GISBORNE WASTEWATER NETWORK – OVERFLOW DISCHARGES: REGULATORY REF: DW-2020-109732-00/WD-2020-109733-00

Further S92 Response 21 April 2021

-  Rainfall Monitoring Sites
-  Flow Monitoring Sites
-  Sewer Main
-  Private Sewer Main

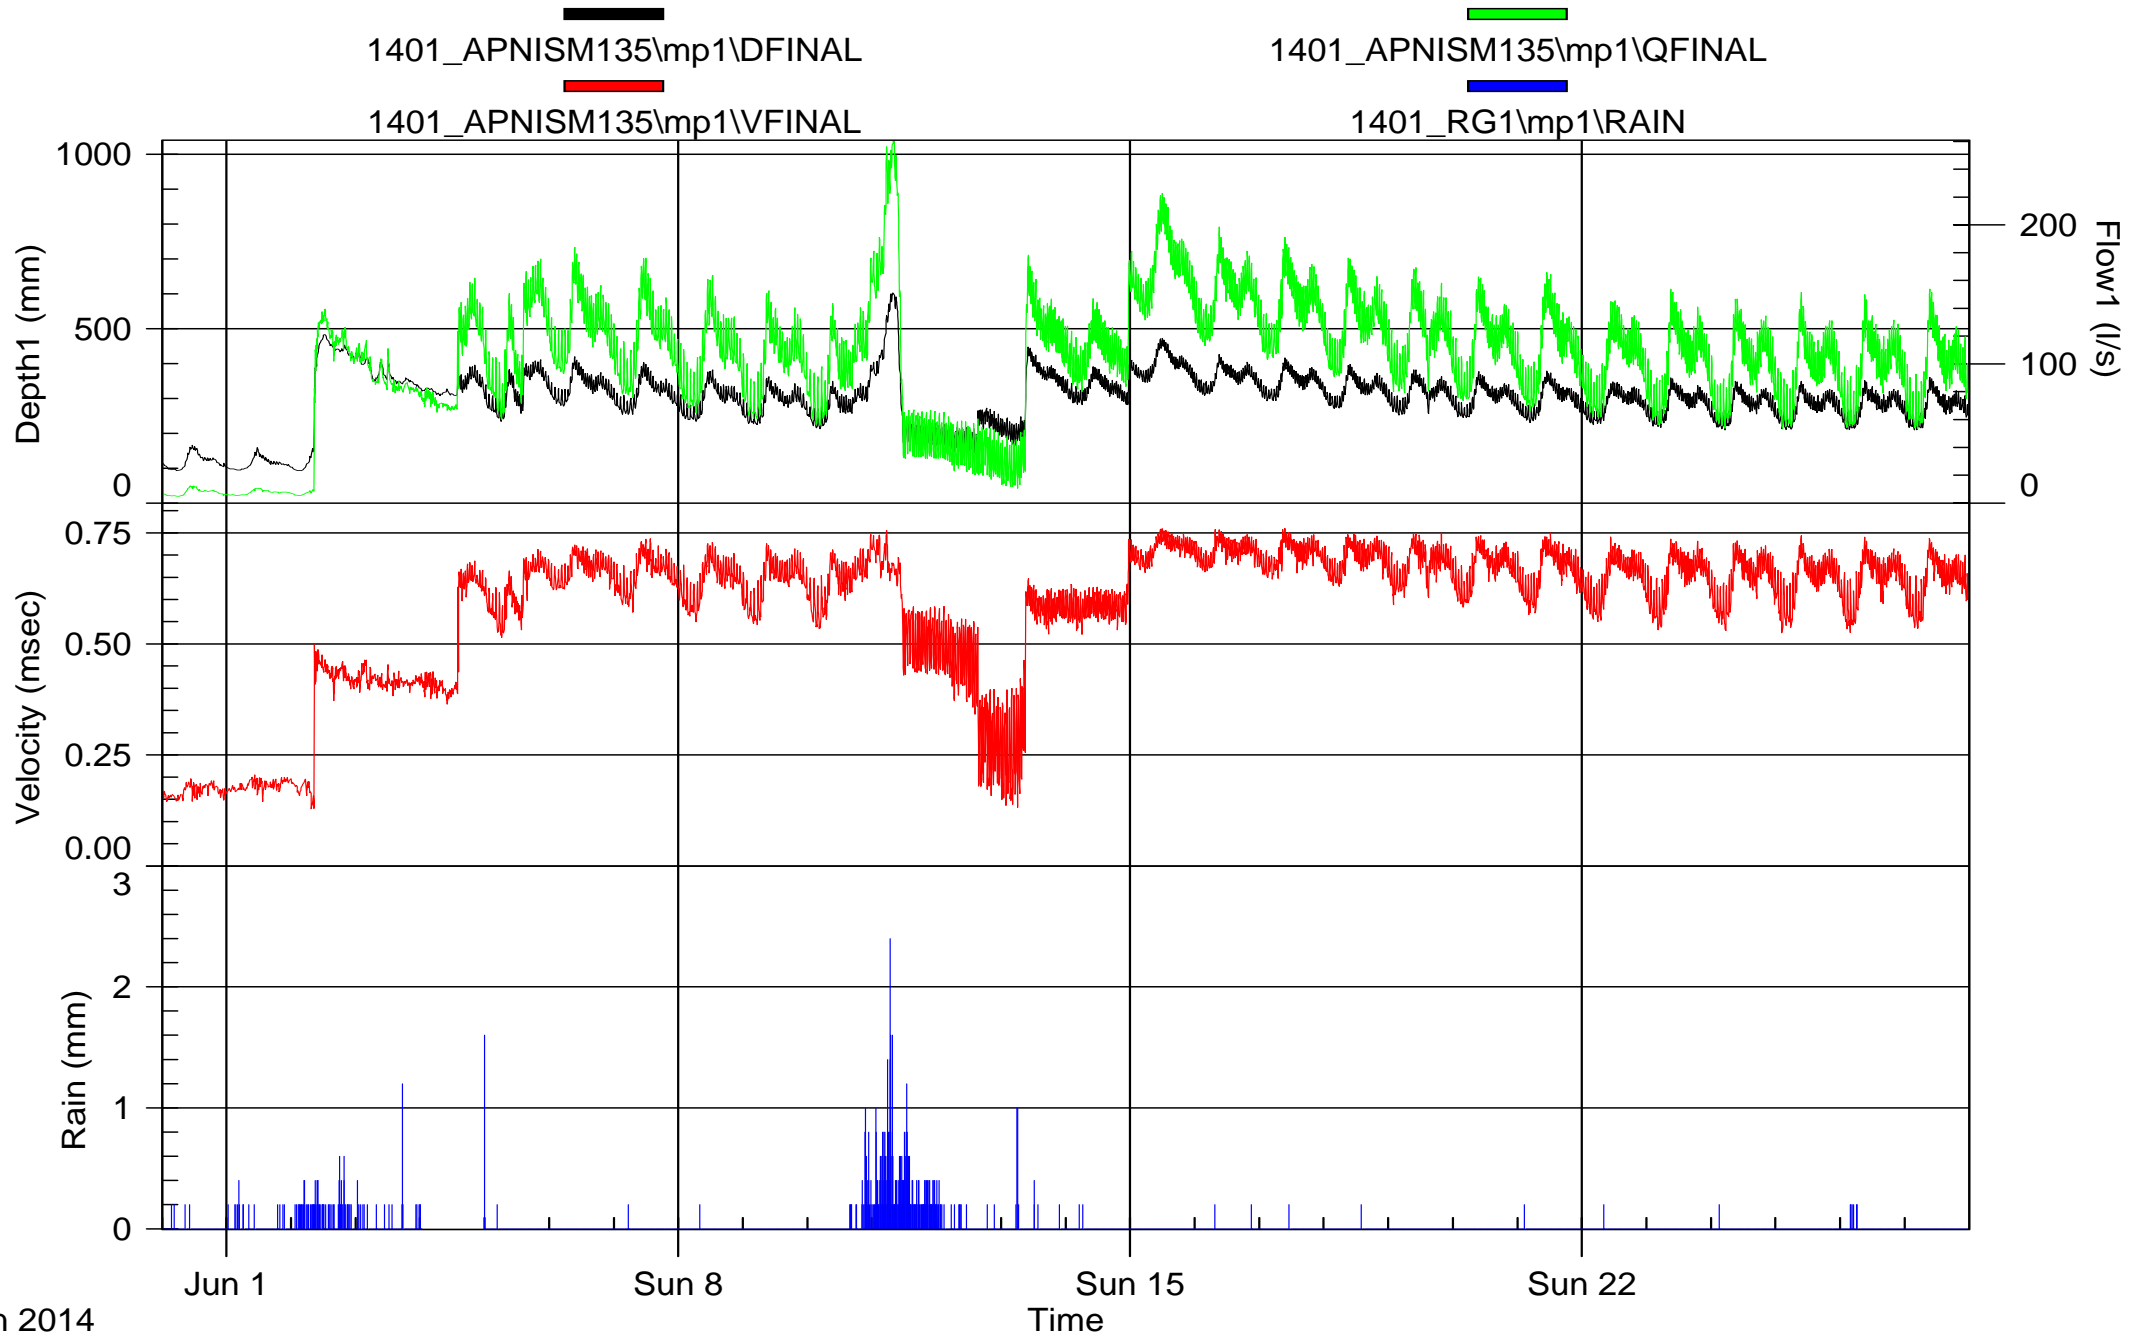
<p>(ii) In the response BECA refer to the following “The flow monitoring undertaken for model calibration provided flow/time graphs which show that the network is dealing with significant direct inflow (fast response), then rain derived infiltration followed by groundwater infiltration - which are consistent with the Water NZ manual”:</p>	
<p>a. Can the applicant provide a map/schematic showing the location of the gauging points and associated</p>	<p>Maps showing the locations of the monitoring points, together with the contributing catchment and network are provided as Attachment A.</p>

<p>upstream wastewater network including pump stations and reference (from the Mott Macdonald gauging report) which locations/hydrographs one(s) show the fast response to direct inflow?</p>	<p>We have also extracted flow monitoring information from the Mott Macdonald report for June 2014 (Attachment B) to facilitate review of the network flow monitoring across the monitoring sites. As can be seen from this extract, all of the monitoring sites show rapid response to heavy rainfall. Some sites to the south of the Taruheru River (eg APNISM135, DISRSM125 and LYTTSM075) also show the influence of overflow valves being opened from 11 to 12 June 2014.</p>
<p>b. Can the applicant provide a map/schematic that show areas of known property flooding referenced in the original application, page 223, see Figure 3-2 from the CH2M Beca Modelling Report, 2017. How does this compare to the nodes identified as flooding in the 2yr-ARI map (Figure B2) in the Beca modelling report.</p>	<p>A map showing indicative property ponding is provided below.</p> <p>The 'Ponding Likelihood' layer predicts where water is likely to pond on a property, based on a number of GIS layers that have been aggregated through a weighting process. These GIS layers include our stormwater flood model, depressions layer, and a Rain on Grid model.</p> <p>Ponding can be affected by many factors, e.g. fences on a property may divert flows, private stormwater sumps and pipes may drain areas, and soil conditions may allow for water to seep into the soil quicker than modelled. The data is also relevant to information available at a specific point in time, and things may have changed over time. Therefore, this layer is viewed as a guide only, as site conditions could be different.</p> <p>The modelled information is based on geospatial modelling, is for indicative purposes only. Council also uses records of actual flooding (surveys and Requests for Service received) and undertakes property inspections / investigations to validate whether or not there are actual effects, and whether or not stormwater drainage improvements (public or private) are required to mitigate the risk of ponding.</p> <p>The nodes identified in Figure B2 have been overlain on the Ponding Likelihood' layer. However, the location of property flooding in heavy rainfall will not necessarily correlate to the location of wastewater overflows from manholes.</p> <p>While property flooding is considered a primary cause of rainwater entering the wastewater system, properties that experience wastewater overflows will not necessarily also be the properties that experience rainwater flooding. Property</p>
